SUPPLEMENTAL FINAL ENVIRONMENTAL IMPACT STATEMENT (SFEIS)

River Knoll

**40 CROTON DAM ROAD
TOWN OF OSSINING
WESTCHESTER COUNTY, NY**

August 16, 2023

On-site Delineated Wetlands
Figure 3.B-3

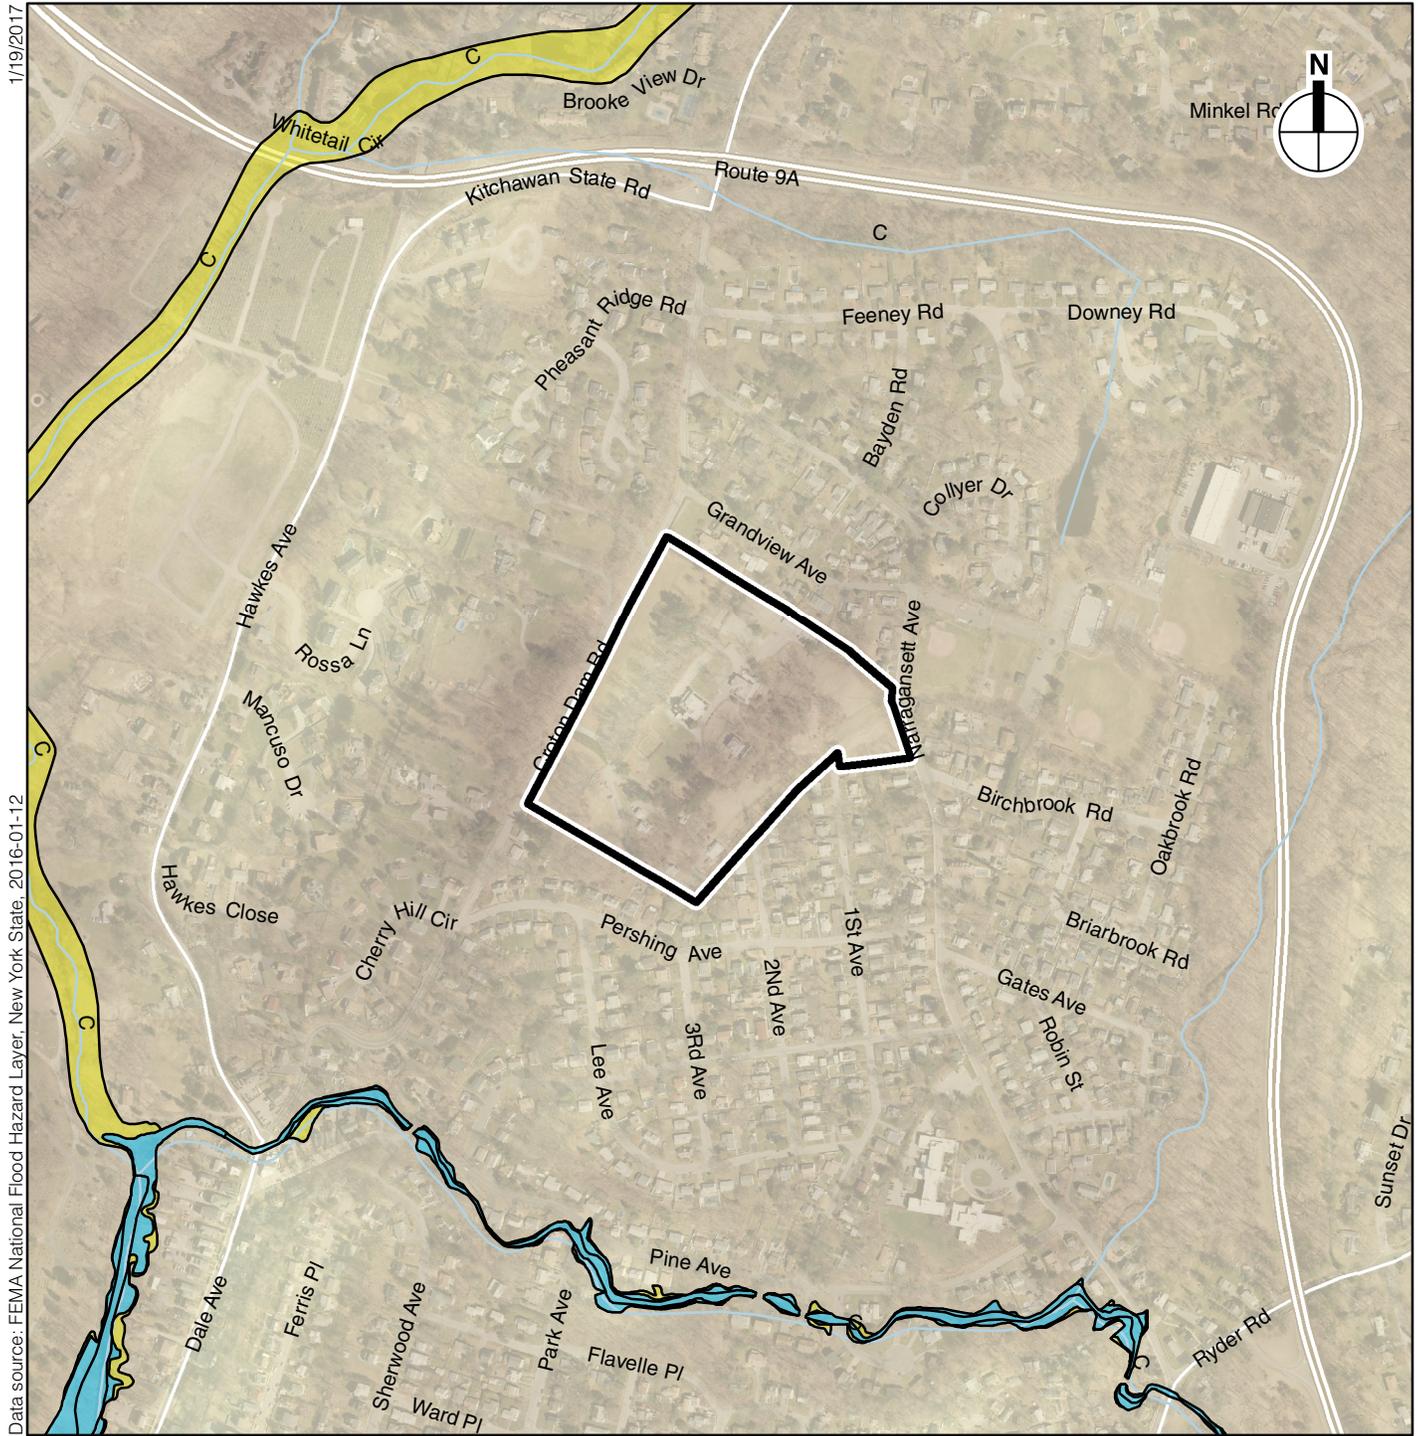
Section III.B.2.i indicates that “the inspections confirmed one small herbaceous wetland of approximately 0.146 acres in size in the northeastern portion of the Project site (see Figure 3.B-3). The wetland is located entirely within the Village of Ossining. The wetland buffer in the Town portion of the site is 0.496 acres in size.” However, III.B.1 indicates that the delineated wetlands within the boundary of the Former Project as such: “a small herbaceous wetland was delineated on-site on September 14, 2015. This wetland was 0.277 acres in size, of which most, 0.273 acres, was located within the Village of Ossining. A smaller amount, 0.004 acres, was located within the Town of Ossining.” Are these statements referencing the same wetland areas? If so, please explain in further detail the discrepancies in size (i.e., why has the wetland area decreased almost by ½ in size from 2015 to 2021?)

This figure has been revised to address the comment (see Figure 3.B-3).
